Geotechnical Investigation Proposed Residential Building

230-232 Lisgar Street
Ottawa, Ontario

Report PG6401-1 Revision 2 dated October 18, 2023

re: Geotechnical Response to City Comments
Proposed Residential Building
230-232 Lisgar Street - Ottawa
to: 230 Lisgar Street Inc. – **Mr. Albert Falsetto** – a.falsetto@rogers.com
to: Fotenn – **Ms. Jillian Simpson** – simpson@fotenn.com
date: October 18, 2023
file: PG6401-MEMO.01 Revision 2

Figure 1 - Approximate Locations of Frost Protection of The Site Servicing and Insulation Recommendations

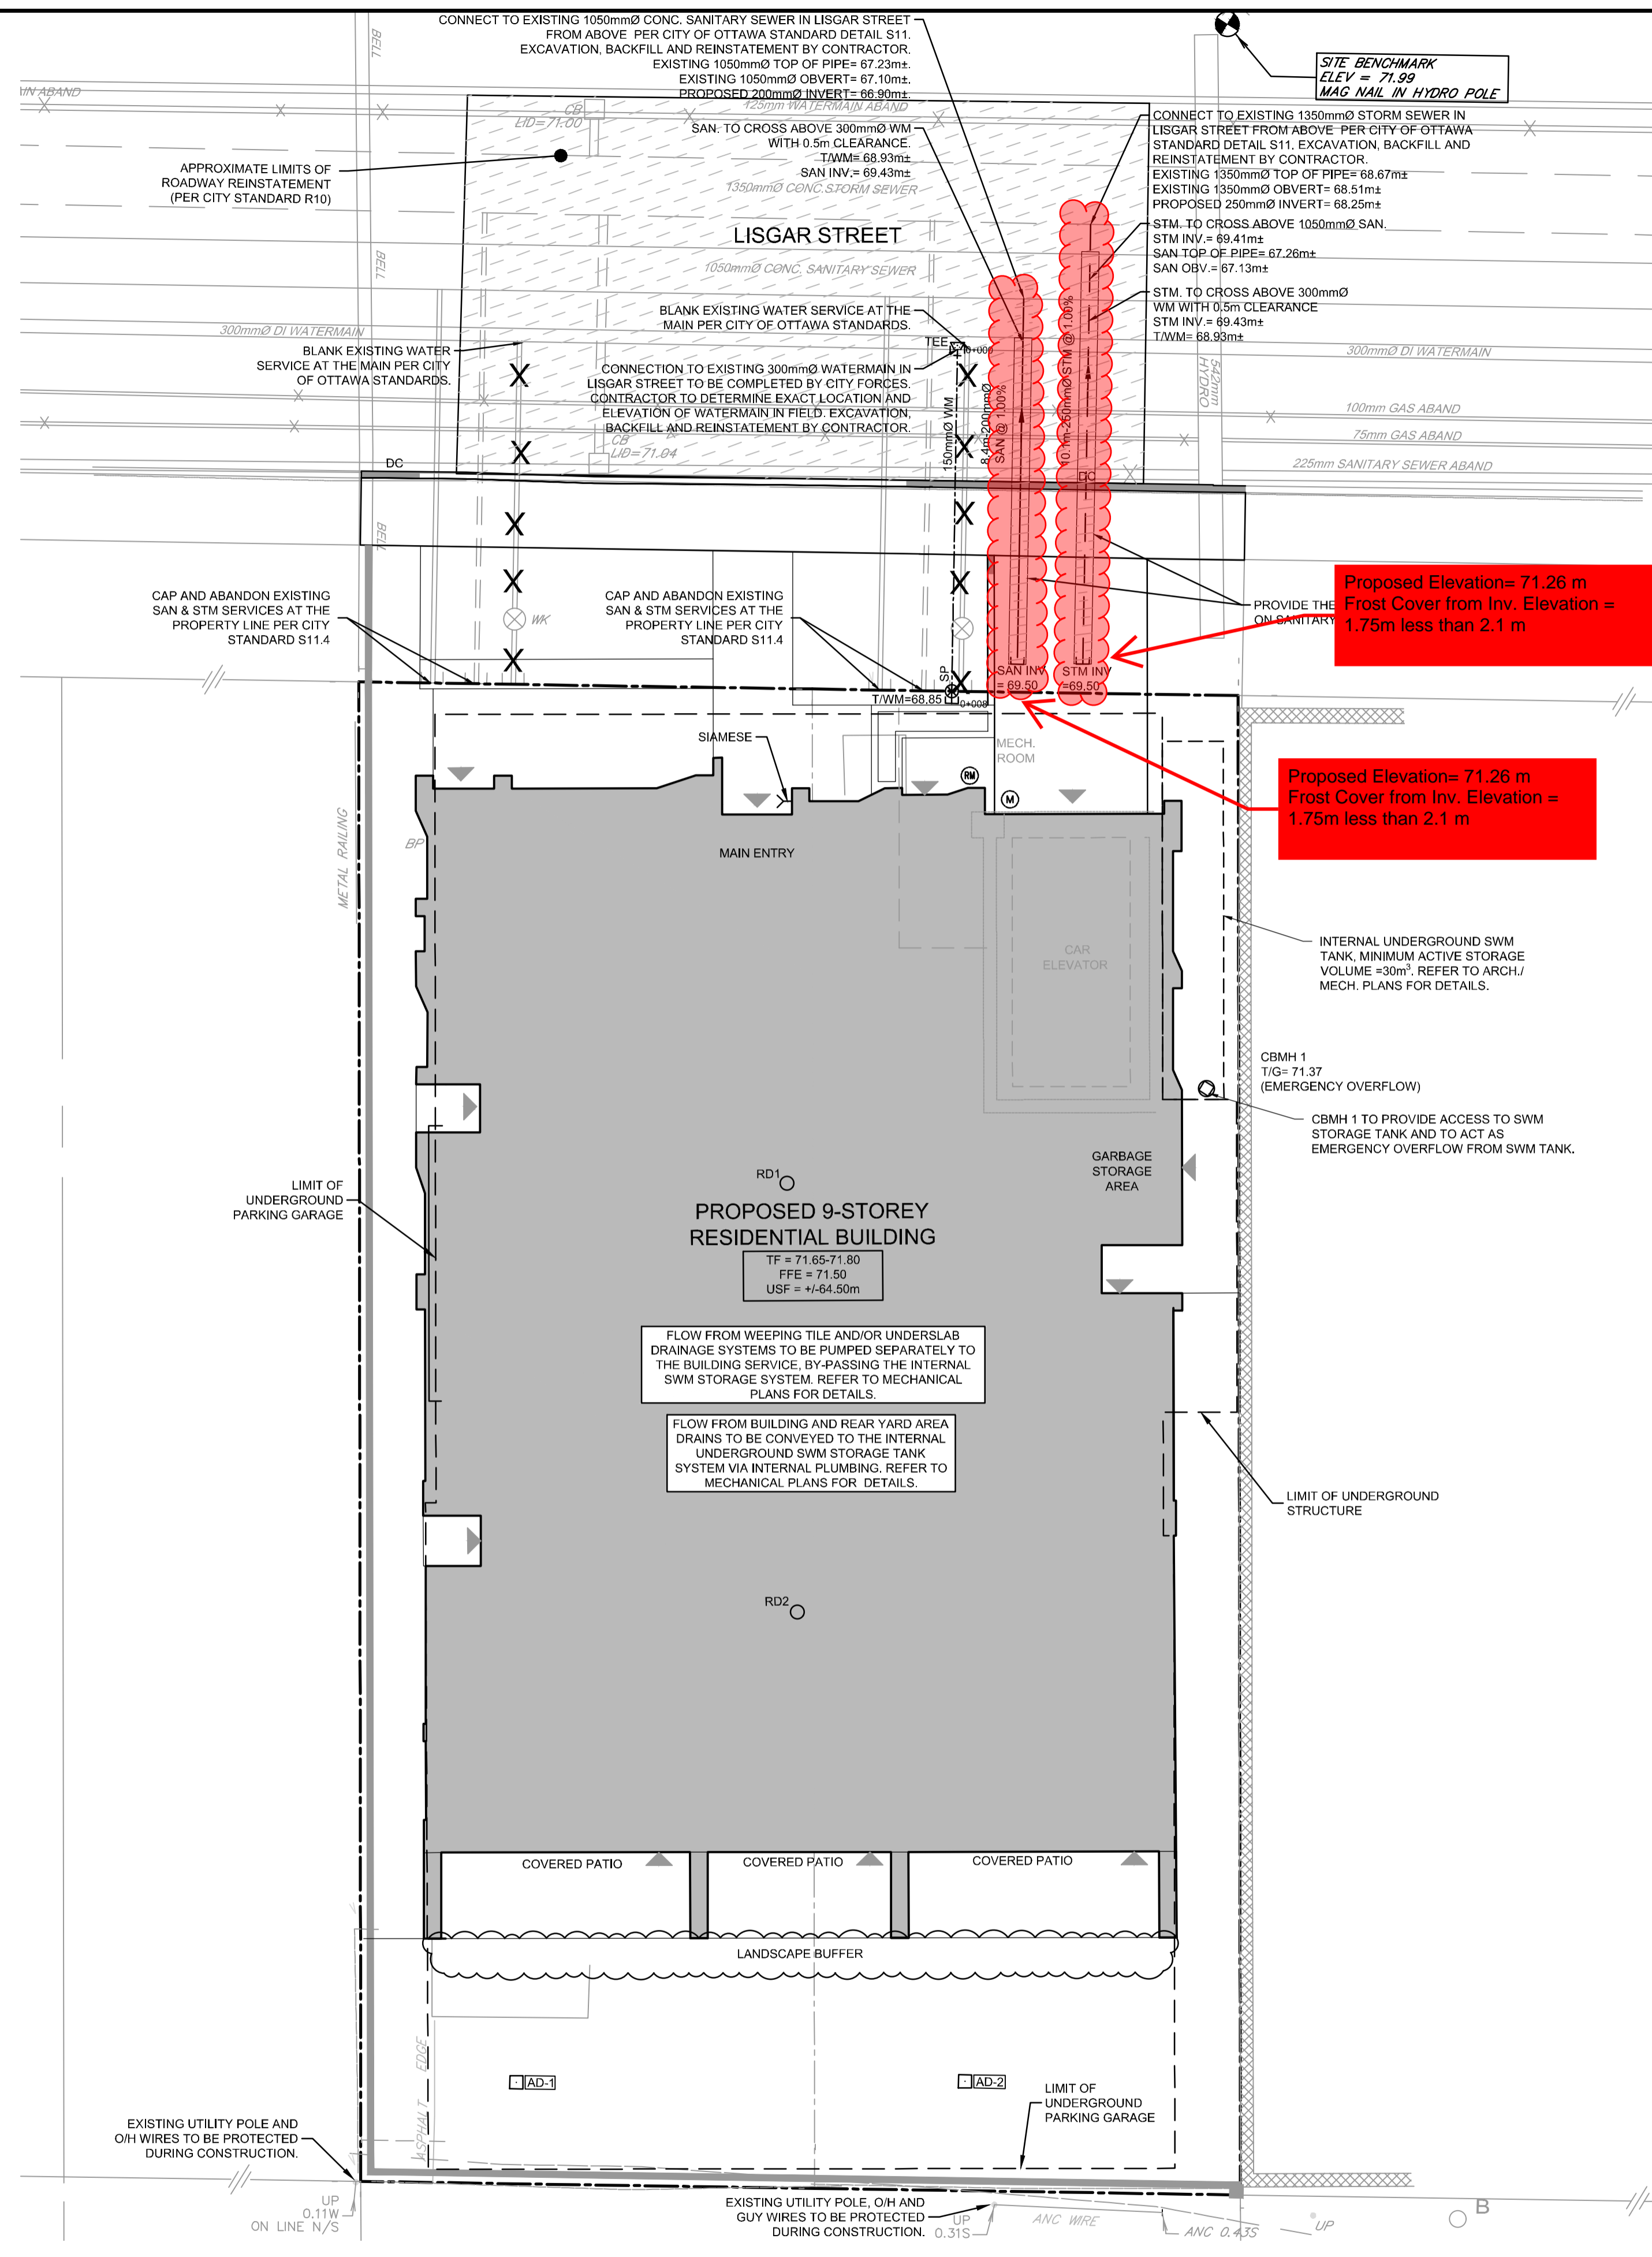
Based on our review of the above noted site service plans, The services were found to be outside of the lateral support zone of the proposed footing and be considered to be acceptable from a geotechnical perspective. However, insufficient frost protection has been provided for the storm and sanitary sewer services. At these locations, the storm sewer services are located within the frost zone, approximately 2.1 m below the finished grade.

Refer to Figure 1, attached to the current memorandum, which demonstrates these approximate locations. In the following section, frost protection of the site servicing is recommended where insufficient frost cover has been provided.
